**From:** Josephine Lowry#ns.aliantzinc.ca [josephine.lowry@ns.aliantzinc.ca]  
**Sent:** November 28, 2006 2:05 PM  
**To:** Myles,Debra [CEAA]  
**Subject:** Whites Point Quarry and Marine Terminal Project Description  
**Attachments:** Whites Point Quarry 7.0 PROJECT DESCRIPTION .pdf

# Whites Point Quarry & Marine Terminal

## *REVISED* PROJECT DESCRIPTION

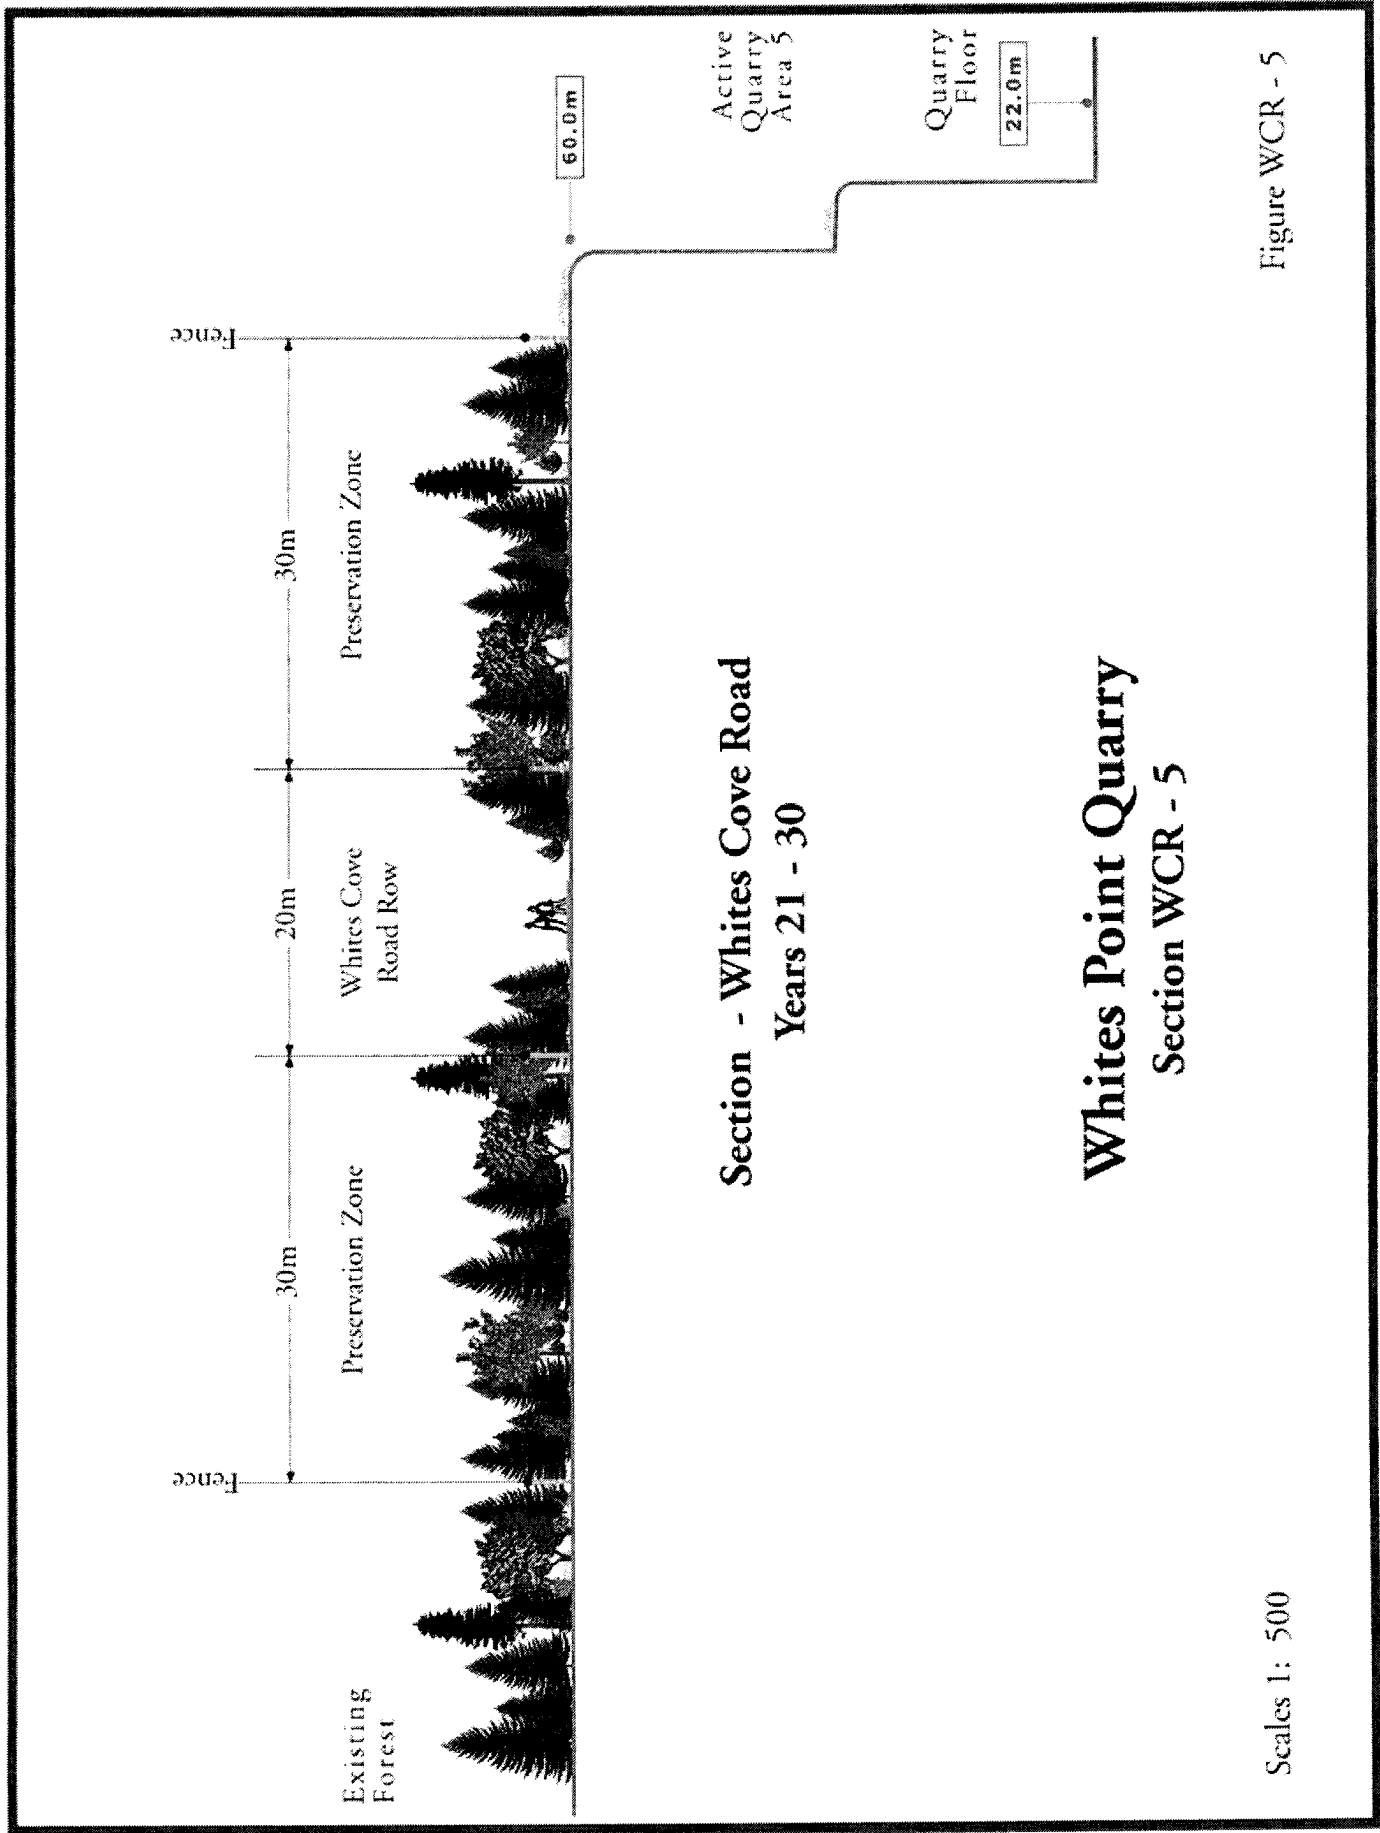
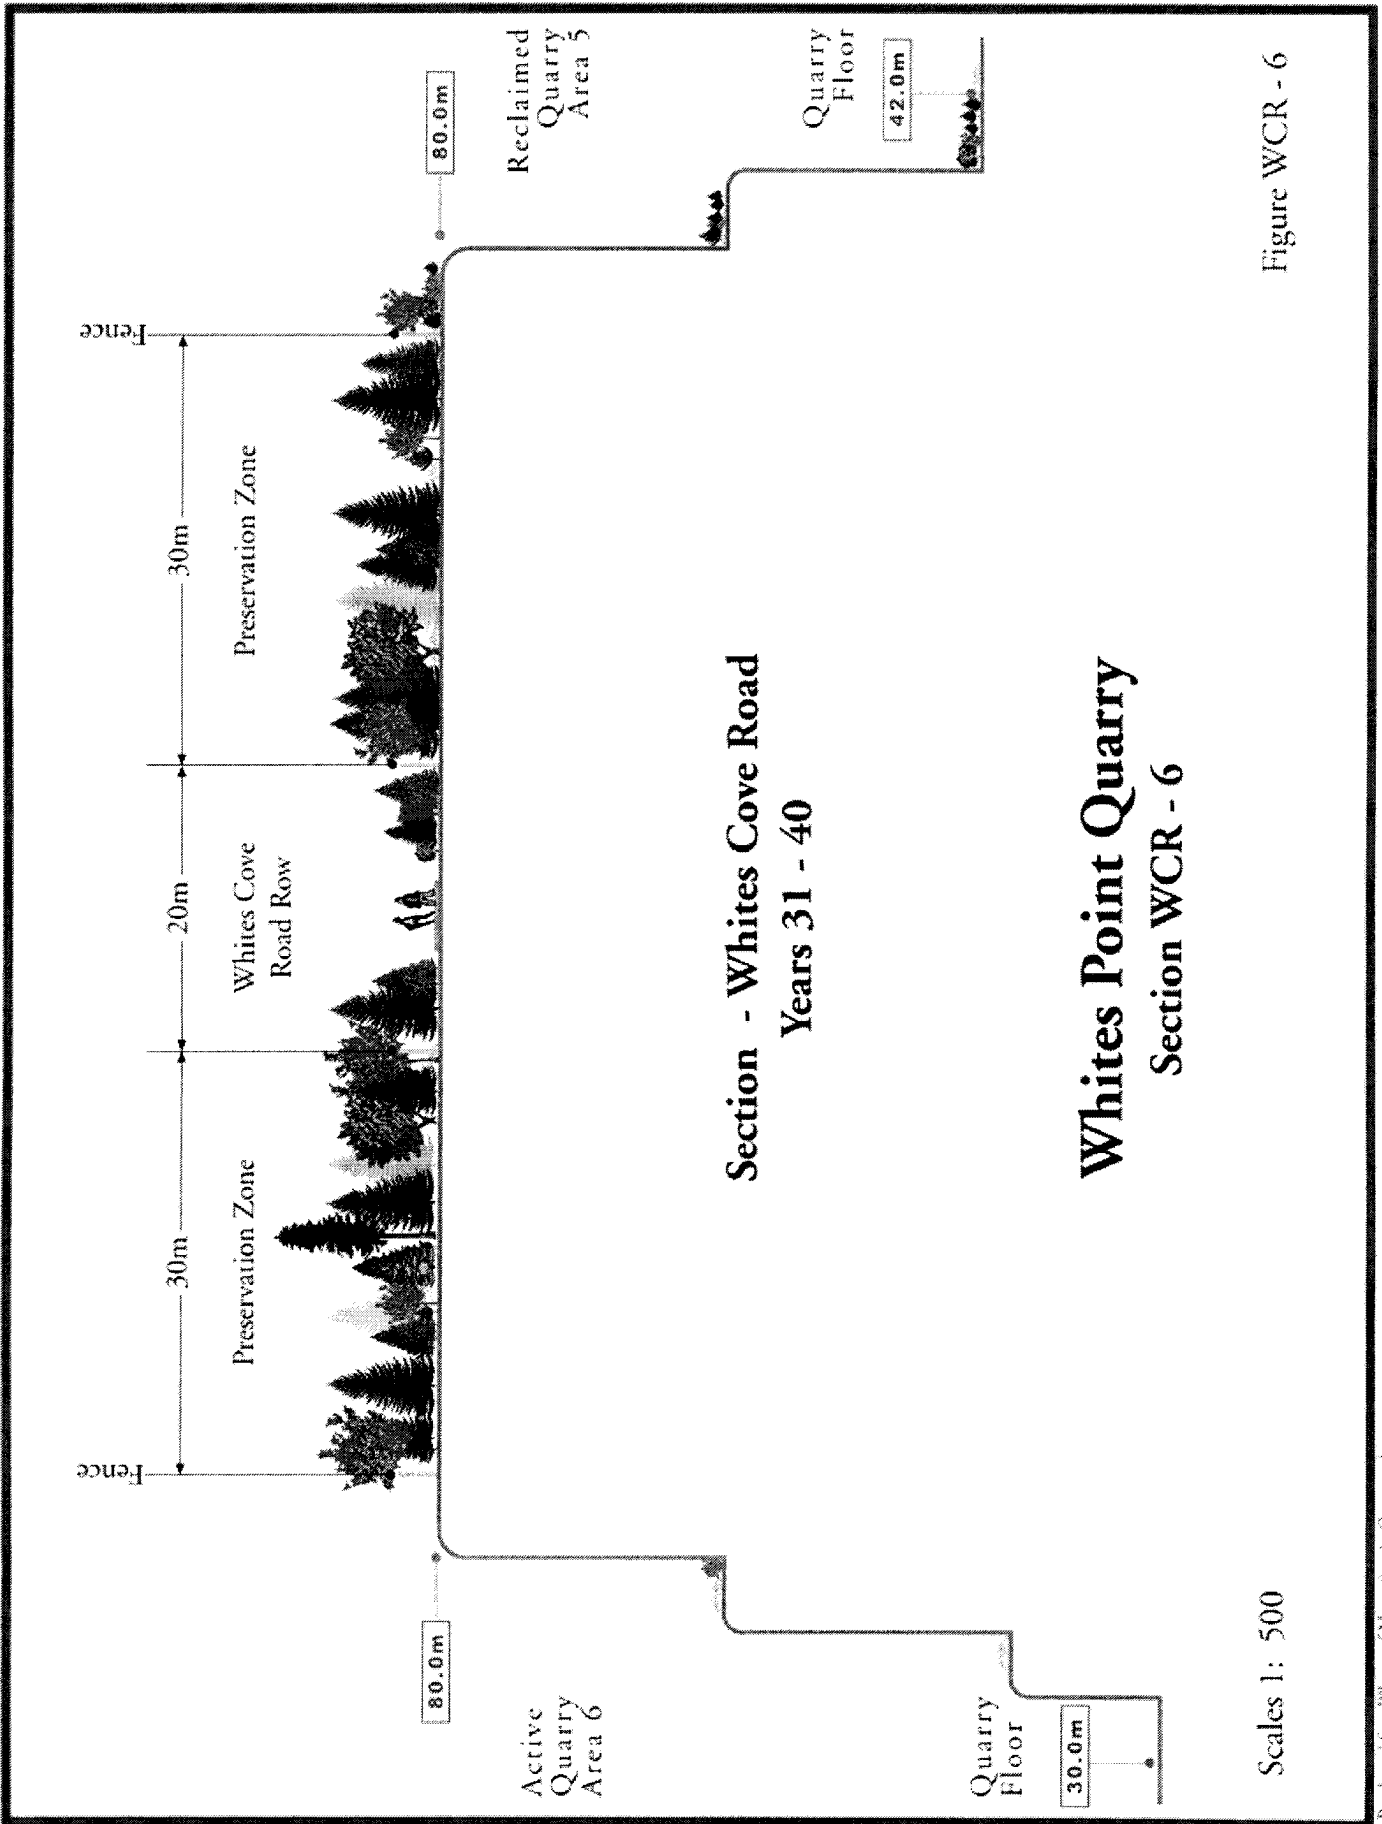
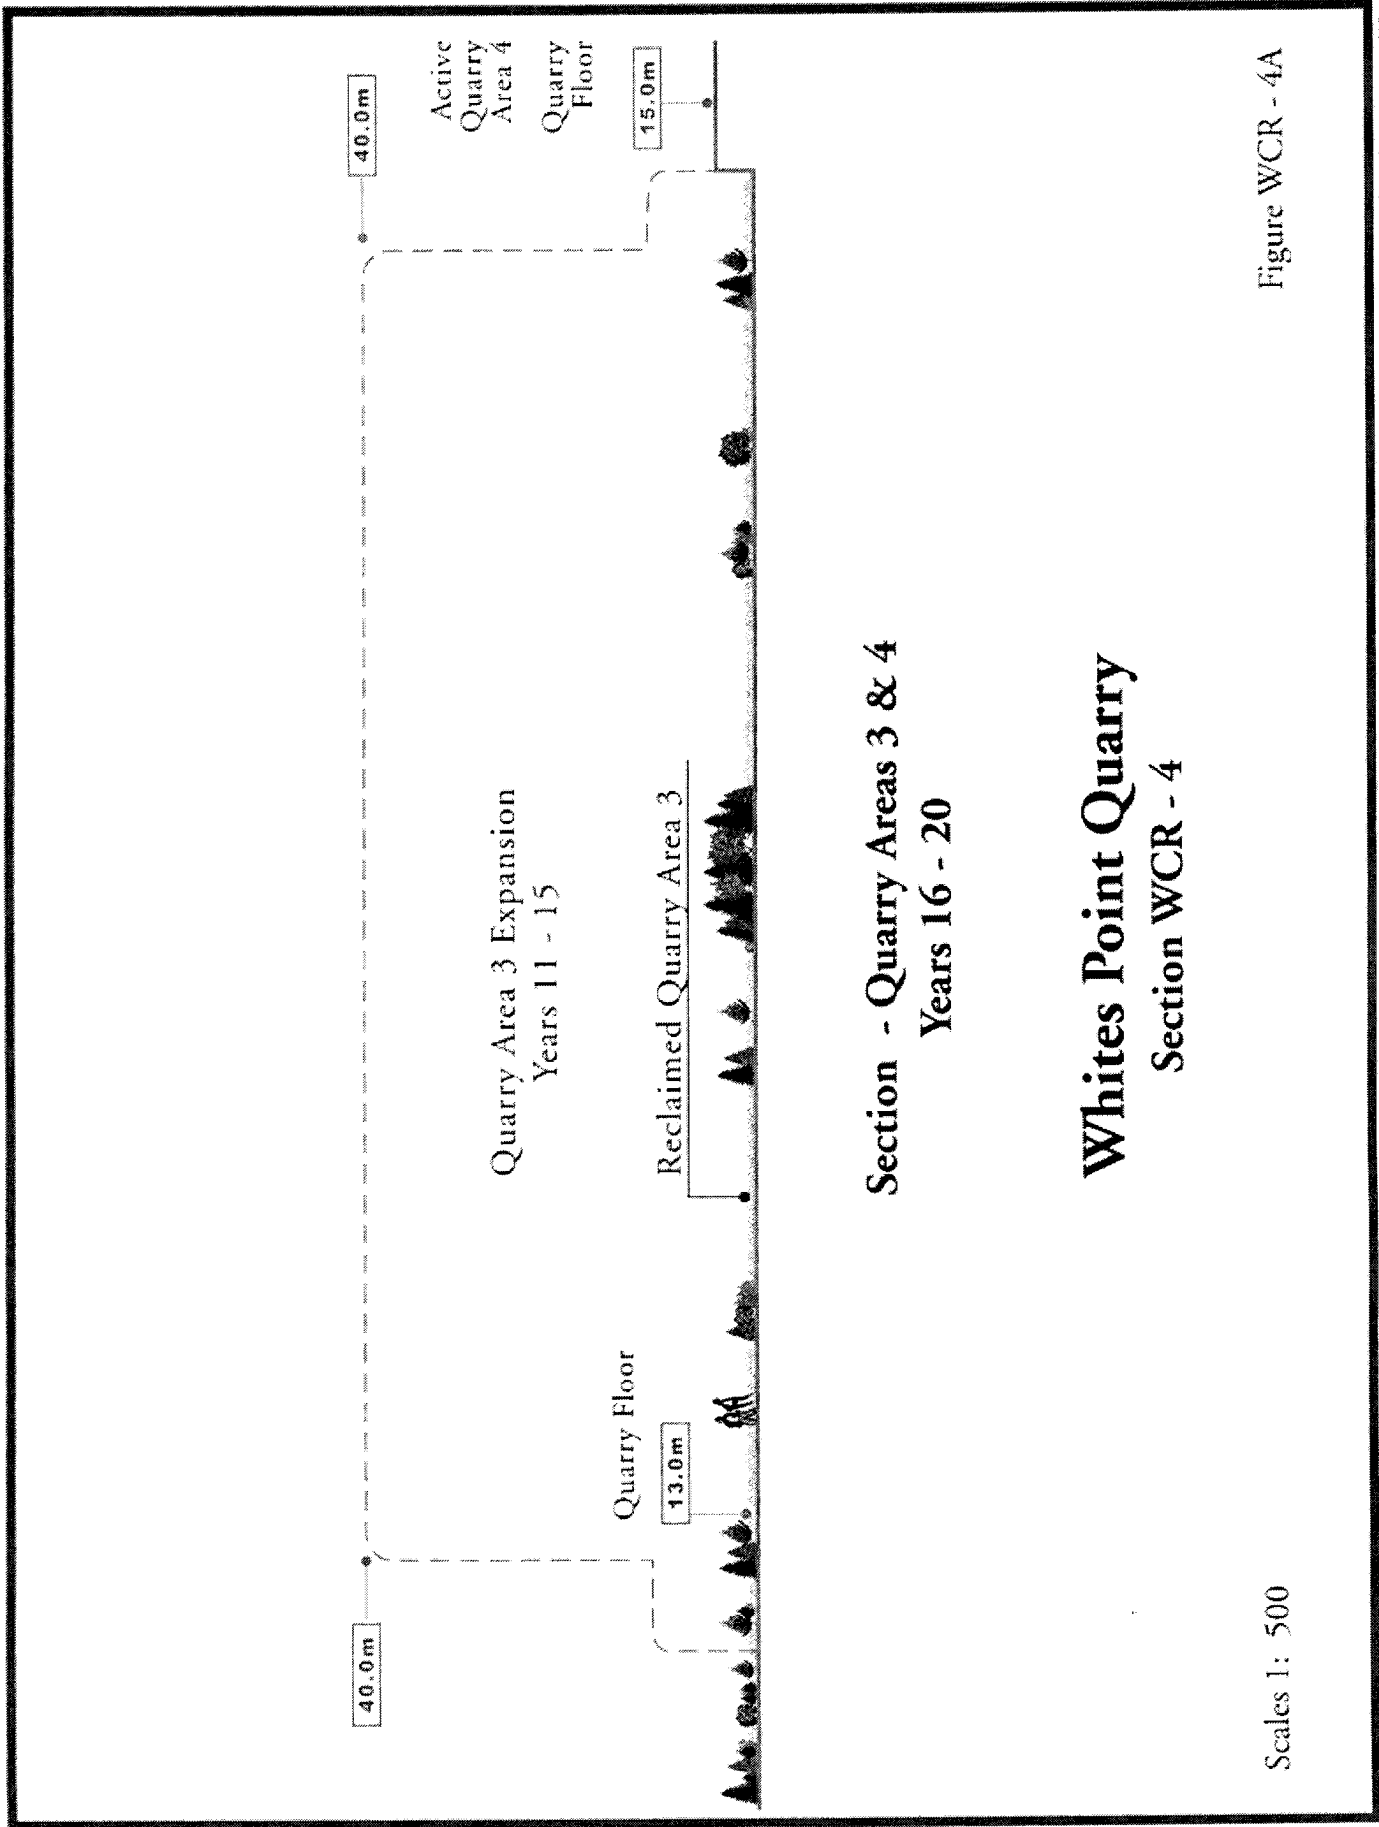
A series of sections are presented on **Figures WCR – 4, WCR – 4A, WCR – 5, WCR – 5A, WCR – 6 and WCR – 6A** to illustrate the quarry operation with and without the Whites Cove Road. The location of where the sections are taken is shown on the Concept Quarry Plans (Mine Plan) **OP4 – R1, OP5 – R1, and OP6 – R1**. Sections for the with and without scenarios are located at the 40, 60, and 80 meter contour elevations along the Whites Cove Road.

- During quarry operational Years 21 – 30, quarry area 5 will begin production. As a result of quarrying in area 5, the situation as shown on **Figure WCR – 5** will result. As shown at the 60m elevation, the existing topography and forest north of the Whites Cove Road will remain unchanged at this time and the quarry floor is approximately 38m below the road to the south.

- During quarry operational Years 31 – 40, quarry area 6 will begin production. As a result of quarrying in area 6, the situation as shown on **Figure WCR – 6** will result. As shown at the 80m elevation, the quarry floor is approximately 50m below the Whites Cove Road to the north and 38m below to the south.

- During quarry operational Years 21 – 30, quarry area 5 south of the Whites Cove Road will begin production. Quarry area 5 would be expanded into the road right-of-way and environmental preservation zone as shown on **Figure WCR – 5A**, at the 60m elevation.

- During quarry operational Years 31 – 40, quarry area 6 north of the Whites Cove Road would be expanded into the road right-of-way and environmental preservation zone. As shown on **Figure WCR – 6A**, at the 80m elevation, the floor of quarry area 5 and 6 will join.
